MIL-PRF-83536/10A
AMENDMENT 4
10 July 1999
SUPERSEDING
AMENDMENT 3
13 May 1999

PERFORMANCE SPECIFICATION SHEET

RELAYS, ELECTROMAGNETIC, ESTABLISHED RELIABILITY, DPDT,
LOW LEVEL TO 10 AMPERES, PERMANENT MAGNET DRIVE, HERMETICALLY SEALED,
ALL WELDED, TRANSIENT SUPPRESSED DC COILS

FIGURE 1. Dimensions and configurations - Continued."

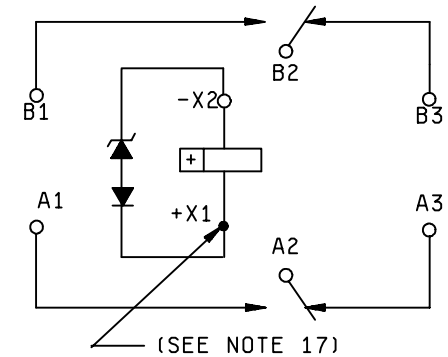
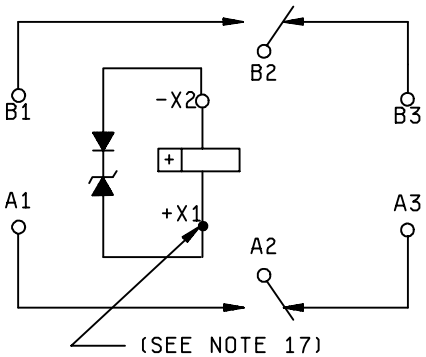
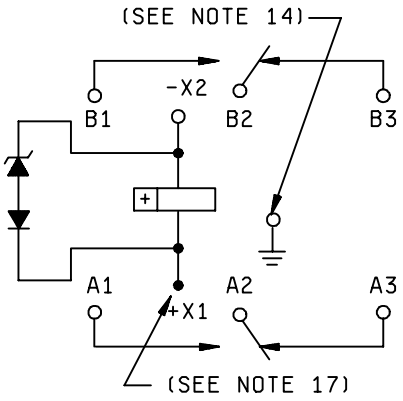
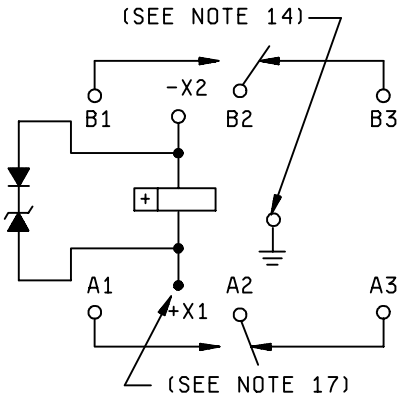
FIGURE 1, delete and substitute:
